HUDSON RIVER PCBs SITE EPA'S PHASE I EVALUATION

Response to Peer Review Questions

Peer Review Meeting
May 4-6, 2010

Resuspension Standard - Existing vs. Proposed

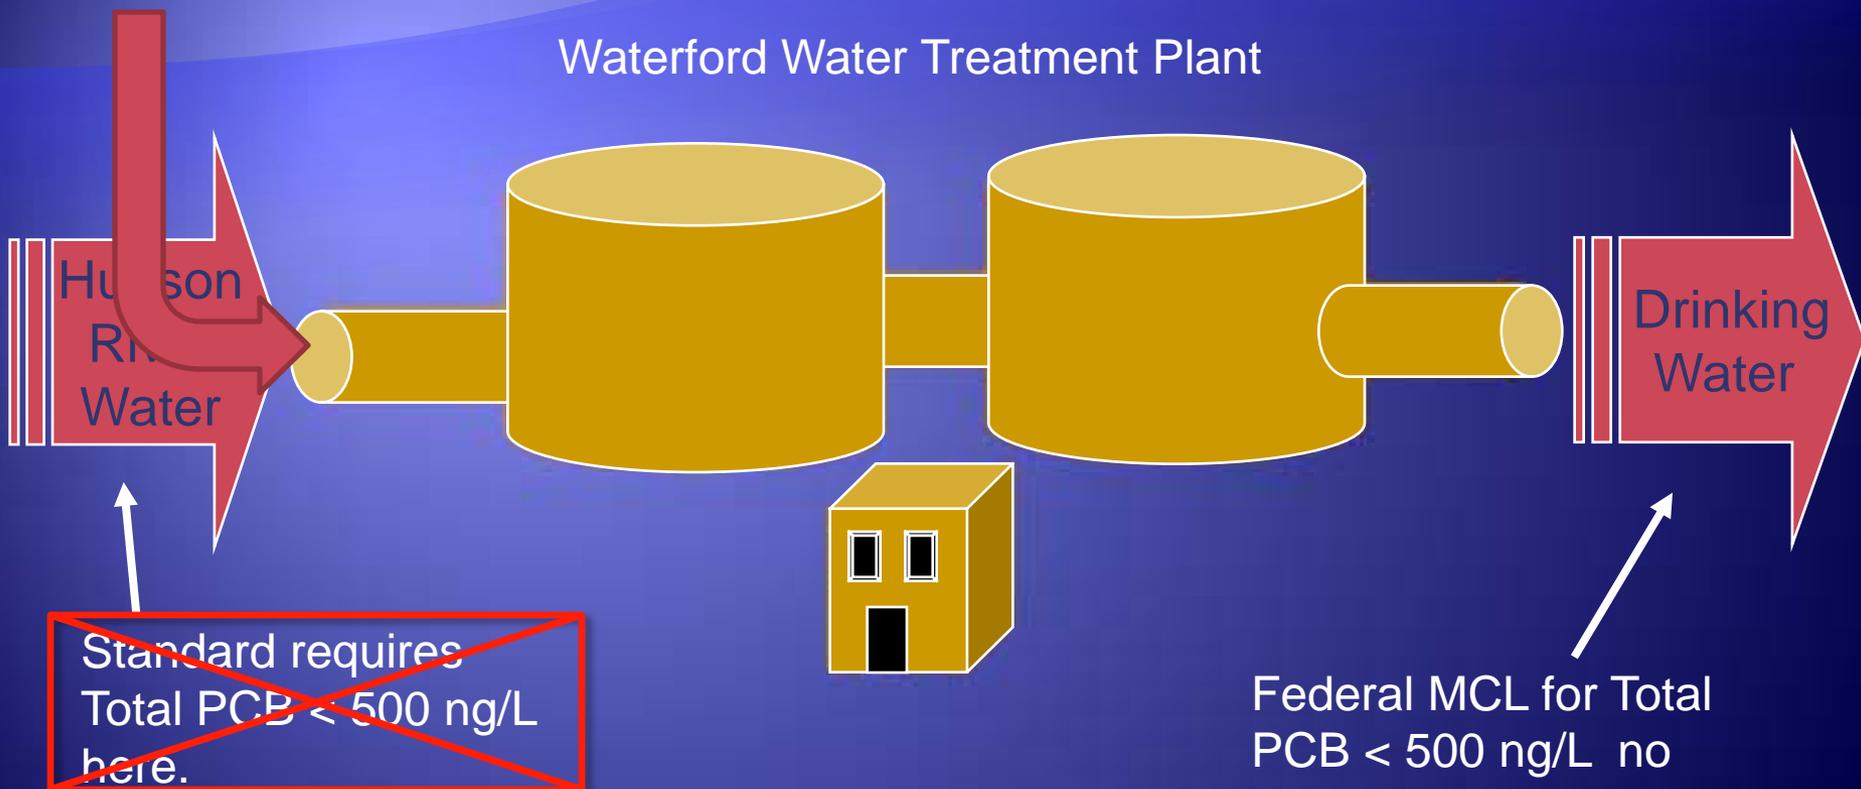
Existing	Proposed Change
<p>Confirmed exceedance of the Federal Drinking Water MCL (500 ng/L) - at any far-field monitoring location. Temporarily halt operations.</p>	<p>Use the 500 ng/L threshold as a trigger to require operational changes, but not necessarily an operational shutdown, at EPA's discretion.</p>
<p>Concern Level - Far-Field Conditions Total PCB Conc > 350 ng/L Total PCB load > 600 g/day Tri+ PCB load > 200 g/day 7-day running average Monitoring contingencies and Engineering evaluation required. No engineering contingencies requirement.</p>	<p>Maintain the water column Control Level of 350 ng/L (7-day running average) for discretionary use by EPA to require (as opposed to merely recommend) appropriate operational changes.</p>

Prediction of Impacts on Fish Tissue Concentrations in the Lower Hudson River due to Dredging

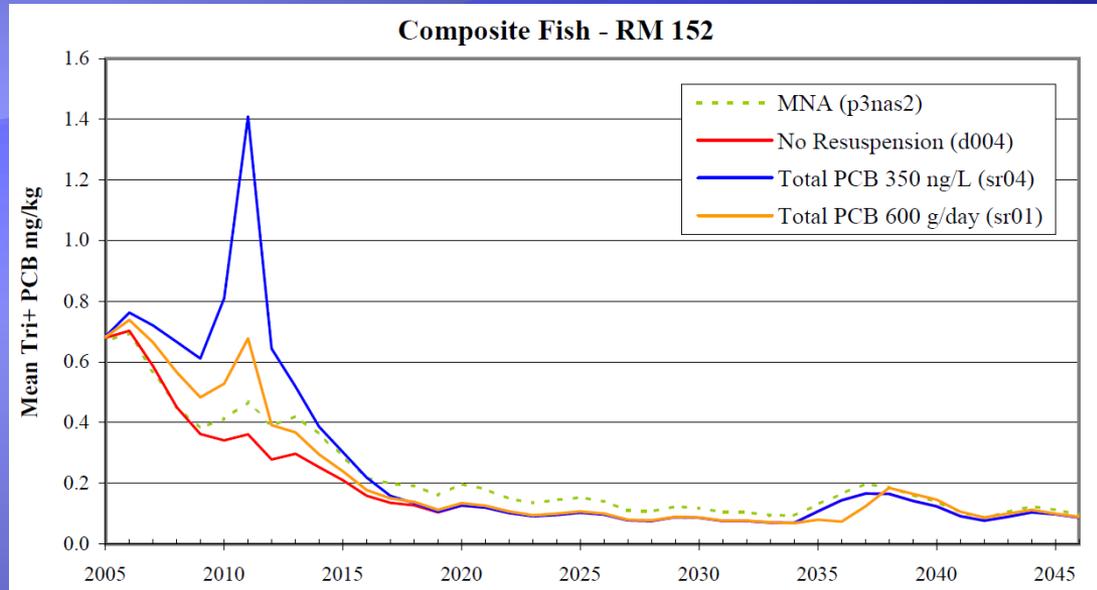
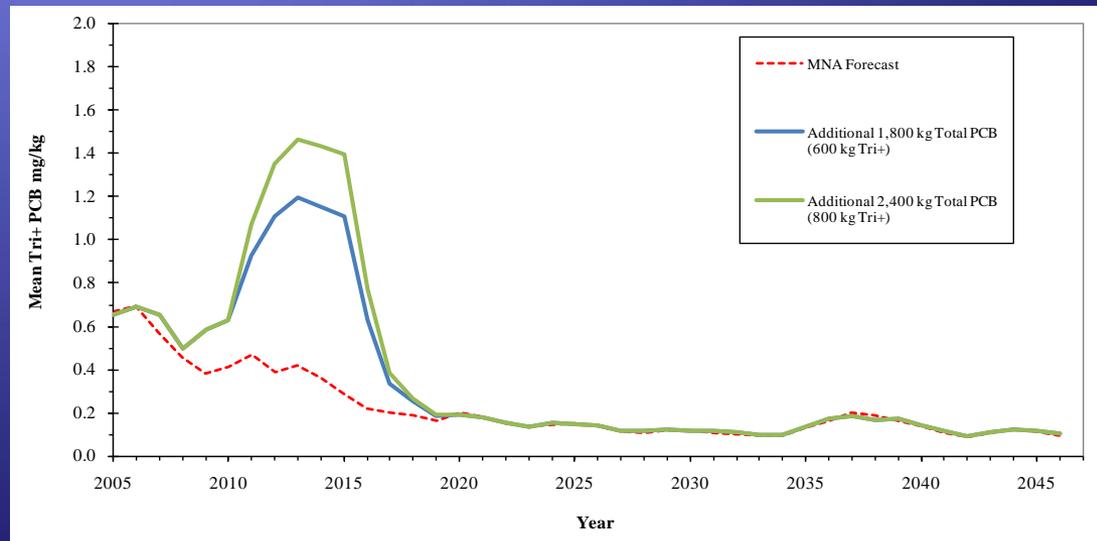
Original
Standard
Basis

Revised
Standard
Basis

Figure 4-A-5. Simulated Cumulative Tri+PCB Load MNA and 500kg Dredging Release Scenario

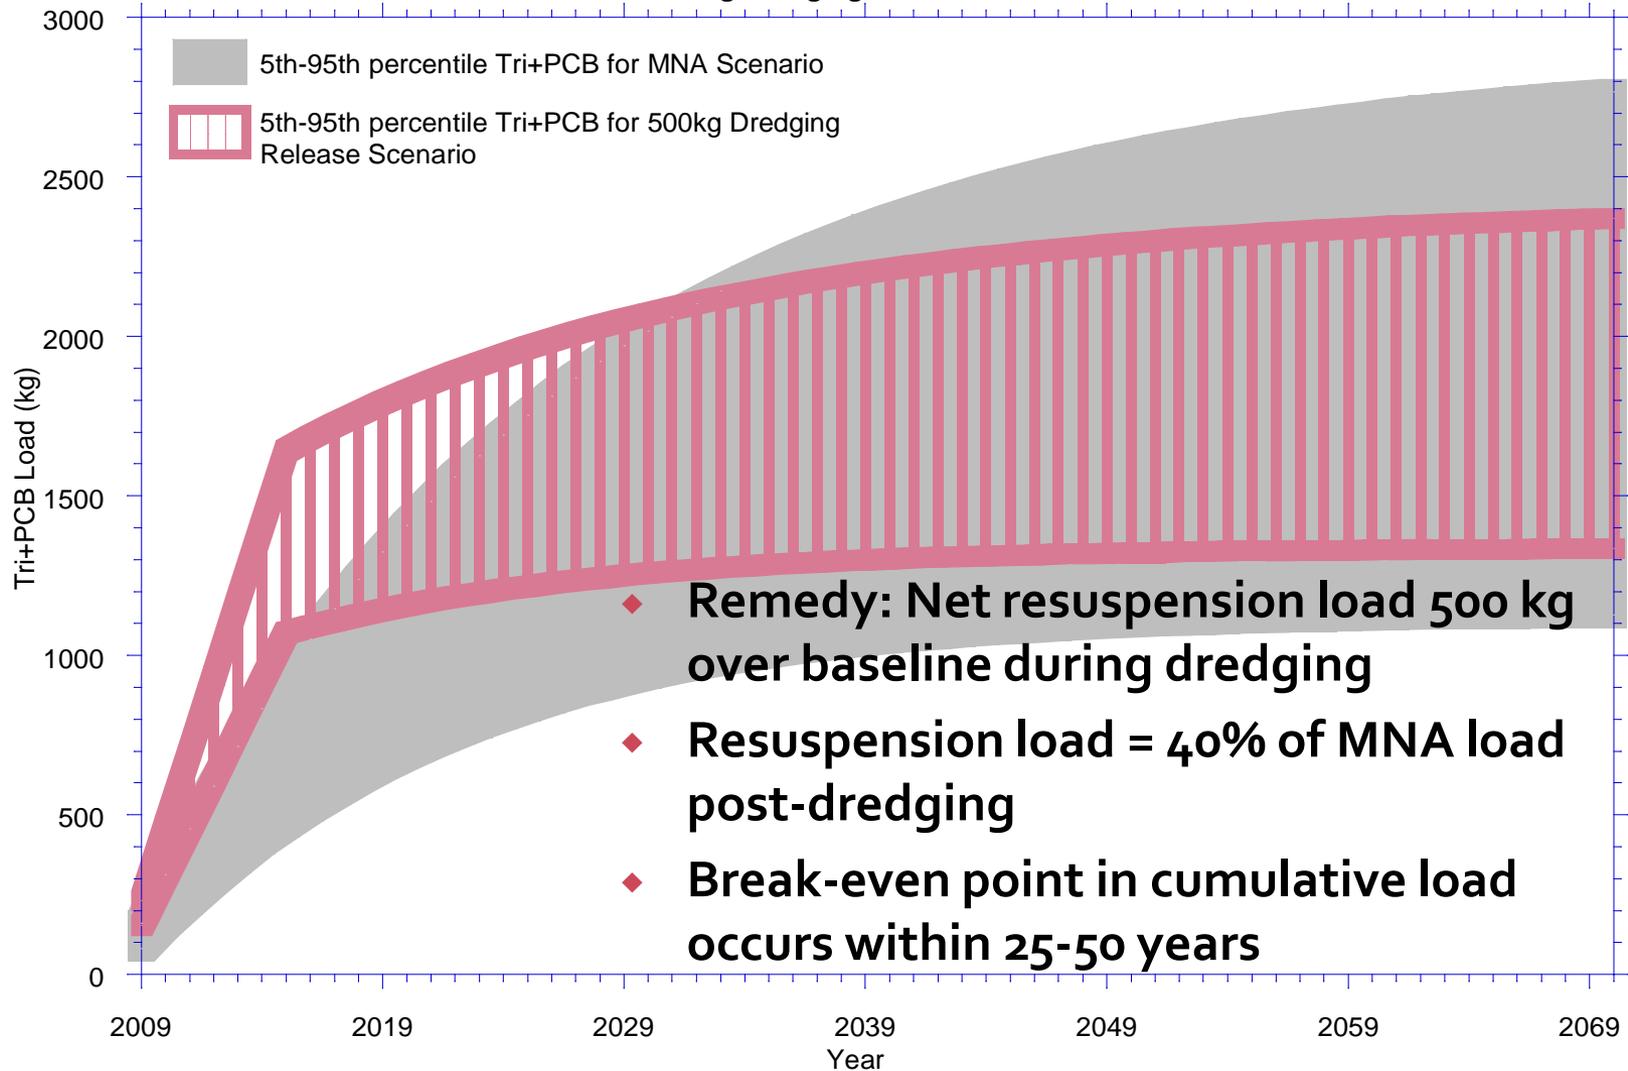
Forecast of PCB Loads Due to Dredging Compared to Natural Attenuation

Figure 4-A-4. Simulated Annual Tri+PCB Load MNA and 500kg Dredging Release Scenario

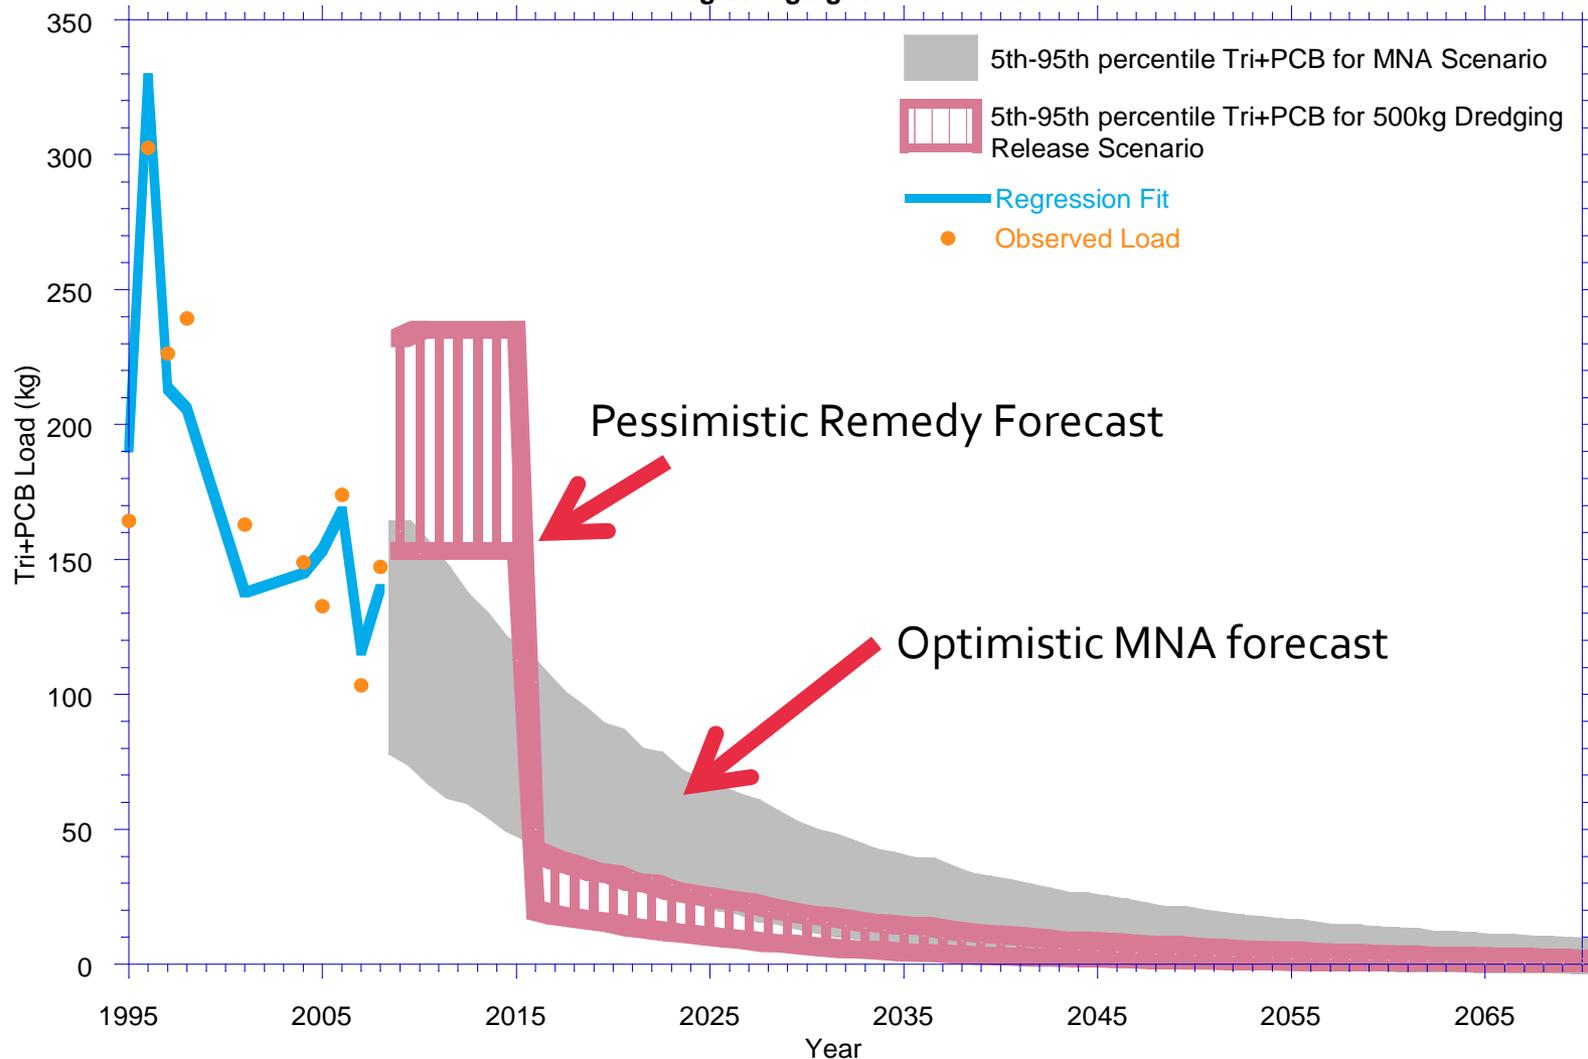
Forecast of PCB Loads Due to Dredging Compared to Natural Attenuation

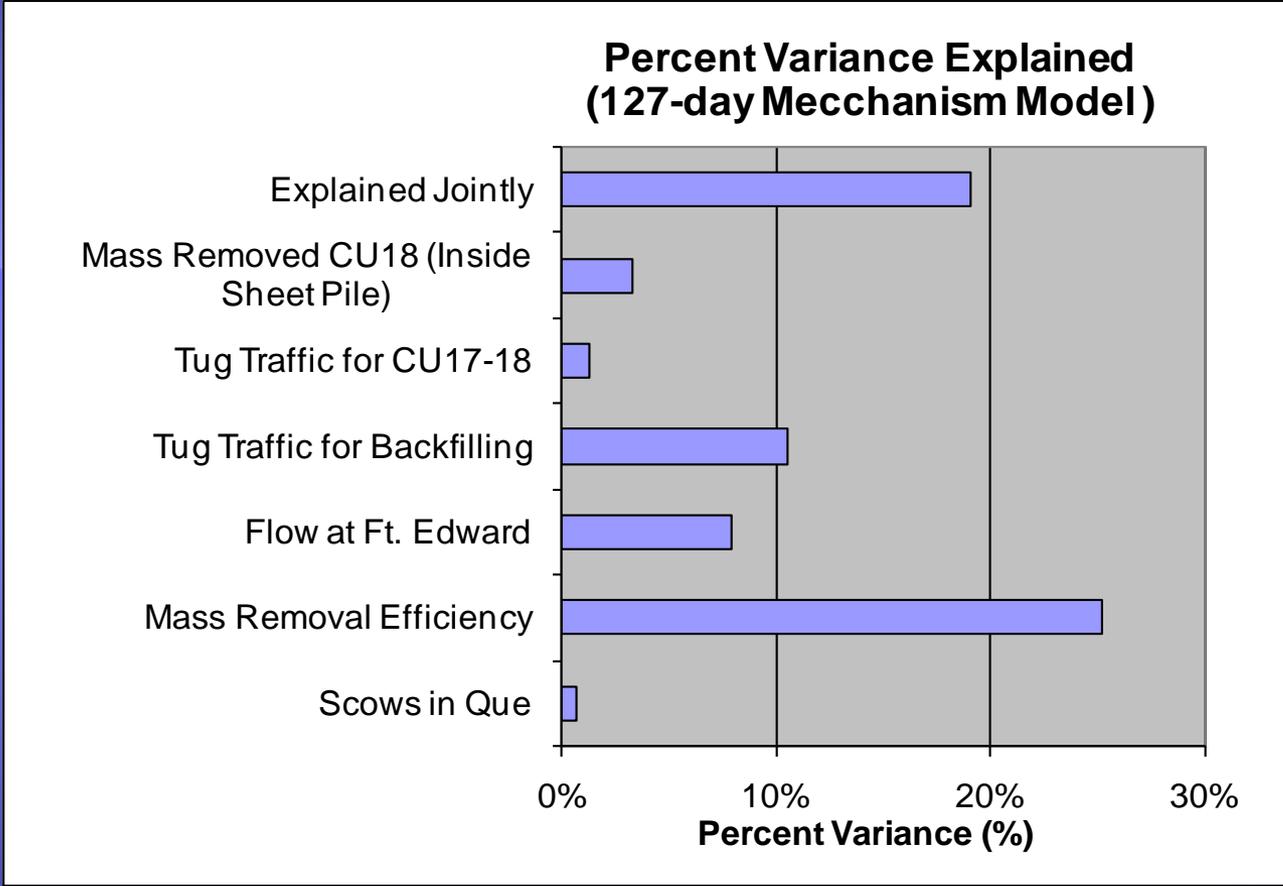
- ◆ A set of 6 dredging related variables were identified that in combination with flow explained 68% of variation in water column PCB concentrations at TID
- ◆ Tug traffic was important, especially in shallow water over high concentration sediments even during backfilling
- ◆ Activities inside CU-18 explained excursions in water column concentrations in late July and early September
- ◆ Less than half of the explanatory power was explained by mass removal alone
- ◆ Operational data from August 10 to September 7 support the conclusion that Phase 2 dredging can be conducted with reasonable resuspension rates while meeting productivity goals.

68 Percent of Locations Required at least 6 in of Additional Dredging

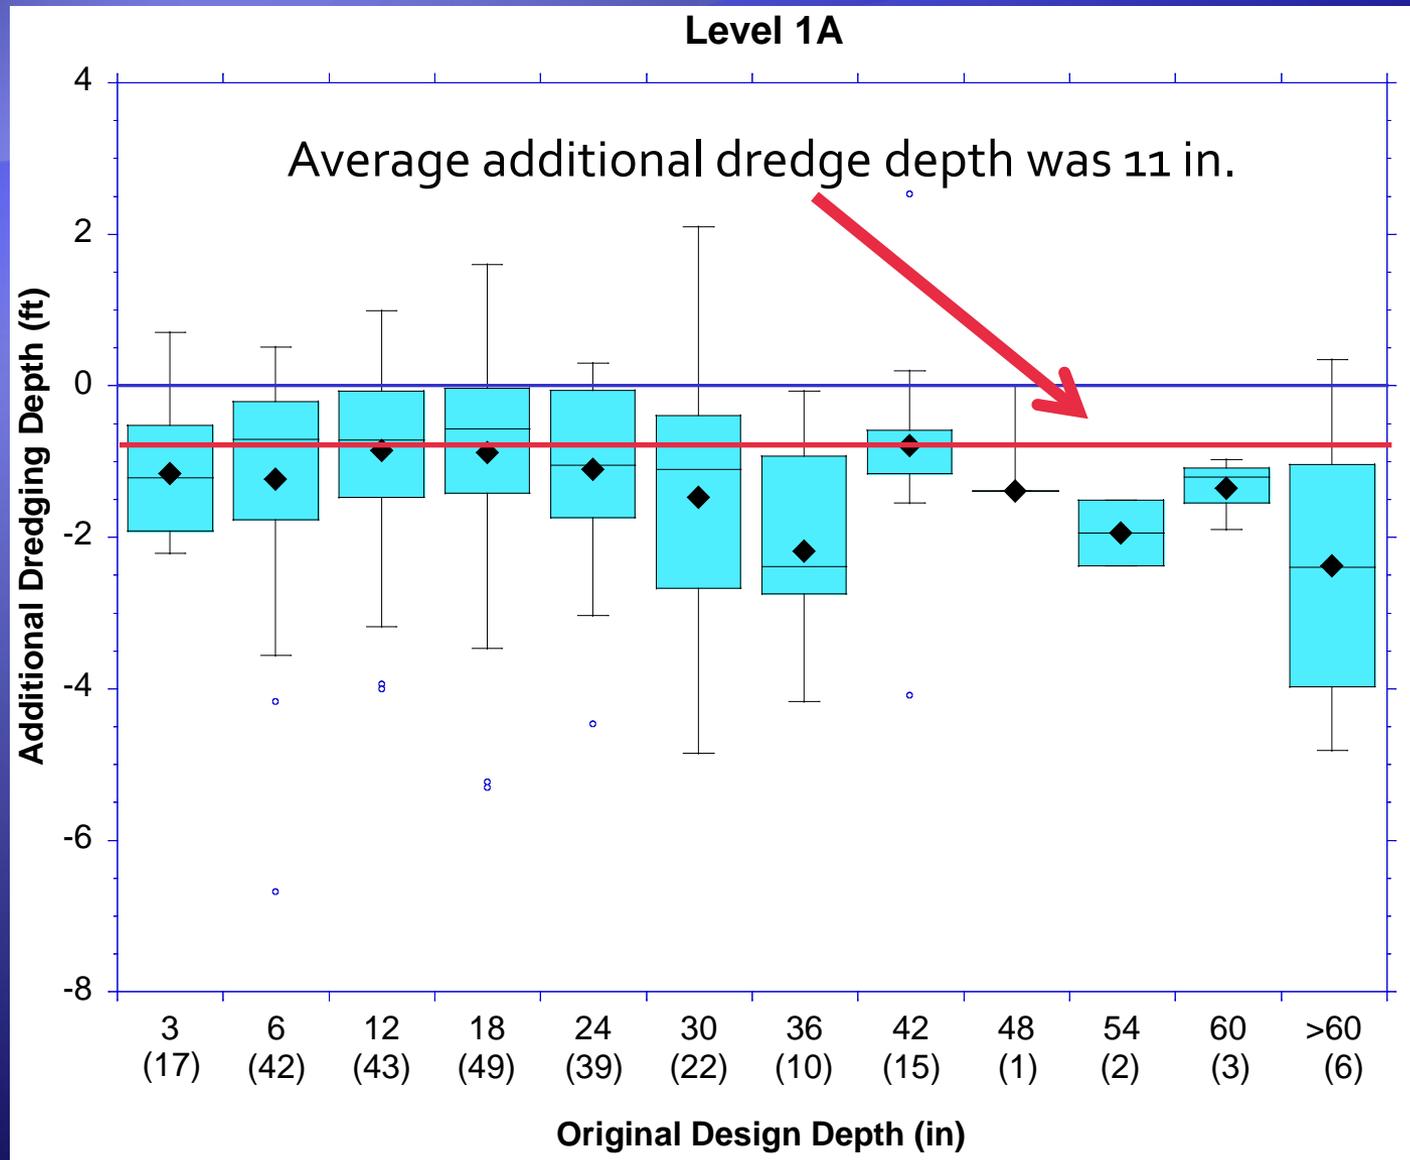
Directly supports EPA's overcut proposal
